U.S. Department
of Transportation
**Federal Highway
Administration**

August 10, 2005

In Reply Refer To: HSA-10/CC-86A

In your July 21, 2005, letter you requested Federal Highway Administration's acceptance of an optional end anchor terminal for the TL-4 Brifen Wire Rope Safety Fence (WRSF). As shown on the attached drawing, this terminal, labeled WRGT-RD, utilizes several components from the crashworthy TL-3 Brifen WRGT end anchor terminal that was accepted by this office on January 28, 2004, (refer to acceptance letter CC-86), but does not require the additional posts used to transition from the TL-3 end anchor terminal to your TL-4 WRSF design that was accepted for use on March 27, 2005, (refer to acceptance letter B-82B). The same 48" diameter concrete anchor and steel anchor frame are used; the first post is placed in a socketed foundation and set at an angle of 79 degrees to horizontal, and the next three downstream posts are spaced at 6'-6" as in the TL-3 WRGT terminal. The overall length of the complete terminal is 27'-10" with the length of need point assumed to be just beyond the fourth post, or approximately 30' from the end anchorage. Rope heights are 36-1/2" to the t

WRGT-RD TERMINAL
(SEE NOTE 1)

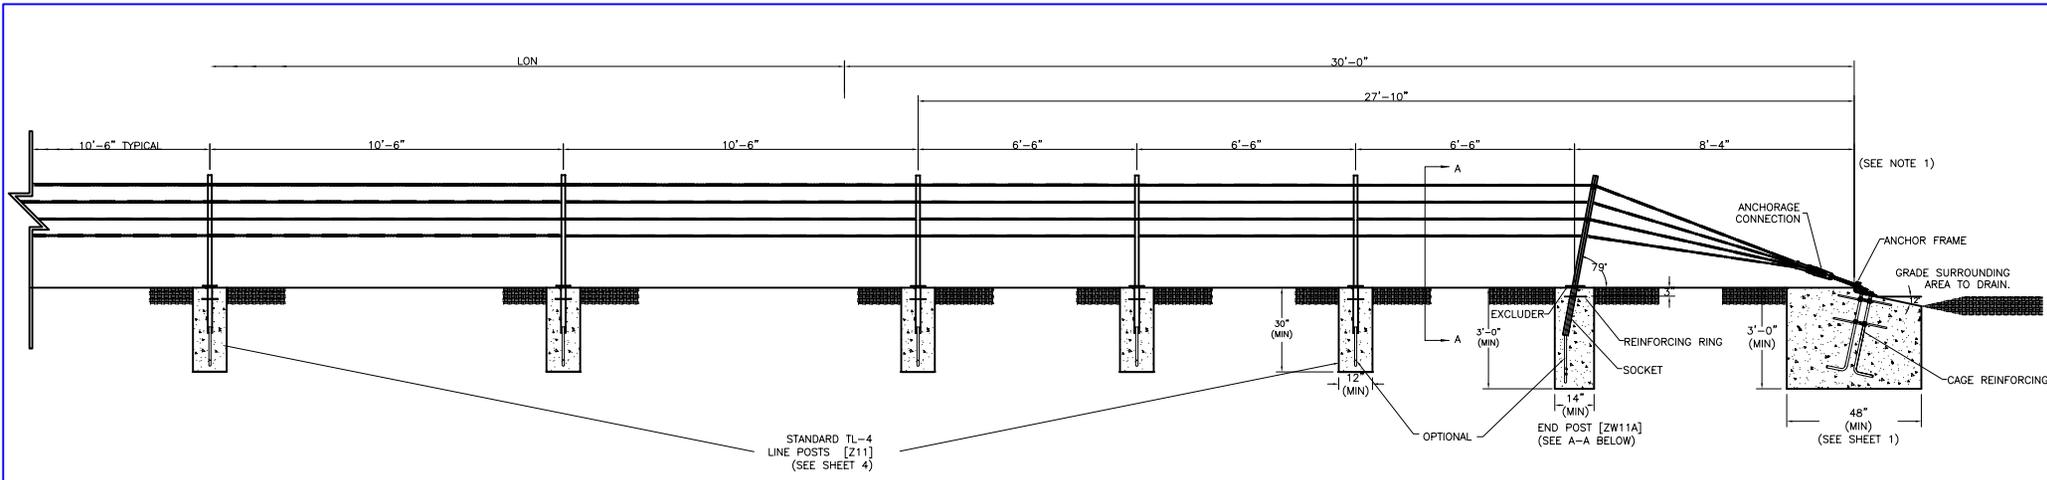
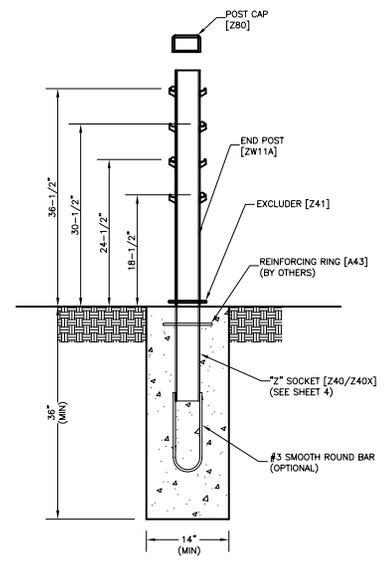
Your letter indicated that this end anchor terminal is intended for use on downstream ends of the TL-4 Brifen WRSF at locations where head-on impacts from opposite-direction traffic are unlikely, behind barriers on approaches to bridges, or as an upstream anchor at locations shielded from head-on impacts from adjacent traffic, such as behind the departure ends of bridges. Provided this terminal is used only in locations where head-on impacts are not likely to occur, as noted above, the Brifen WRGT-RD end anchor terminal is acceptable for use with your TL-4 system on the National Highway System when specified by the contracting agency.
